**PLANNING COMMISSION SITE PLAN
CONDITIONAL USE PERMIT REVIEW SHEET**

CASE NUMBER: SPC-2019-0590A **PC DATE:** 08/25/20

PROJECT NAME: 76 Rainey CUP

PROPOSED USE: Cocktail Lounge

SITE PLAN - CUP

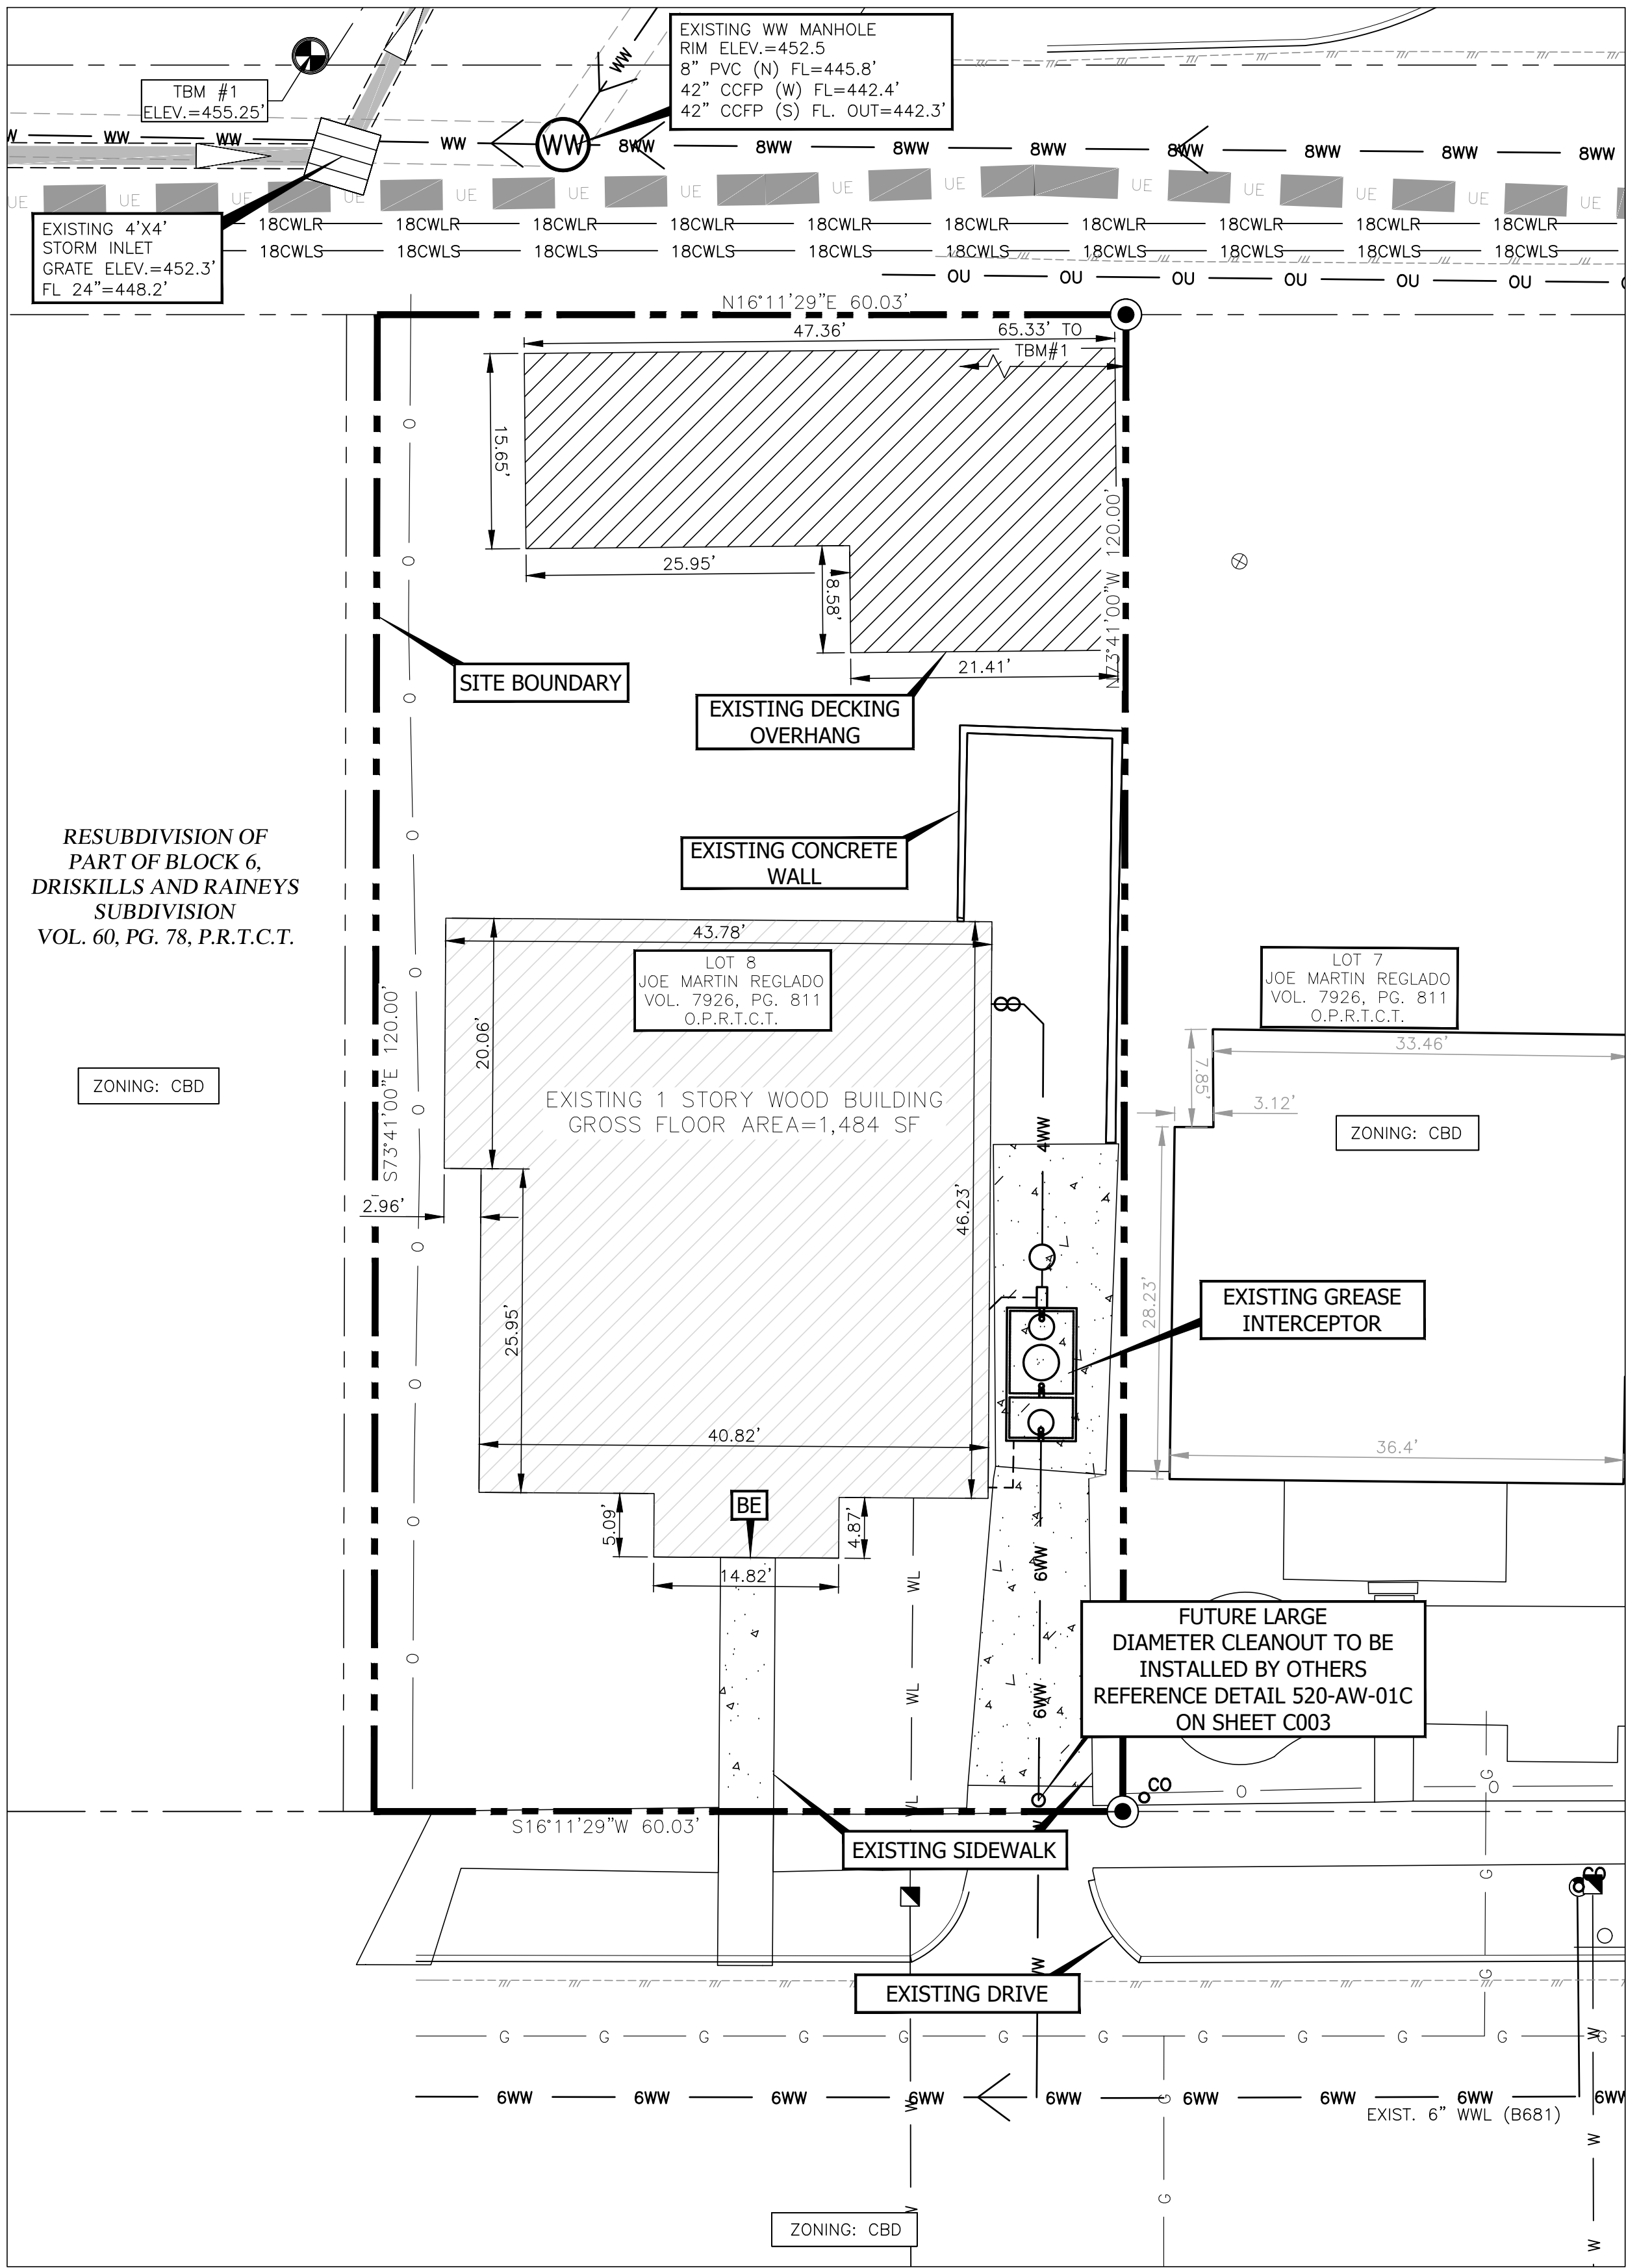
SUMMARY COMMENTS ON SITE PLAN:

Land Use: The applicant is requesting a Conditional Use Permit for a Cocktail Lounge land use. The existing building is within the historic Rainey Street District. There are no parking requirements for this site because the zoning district CBD does not require any parking.

The site plan complies with all requirements of the Land Development Code.
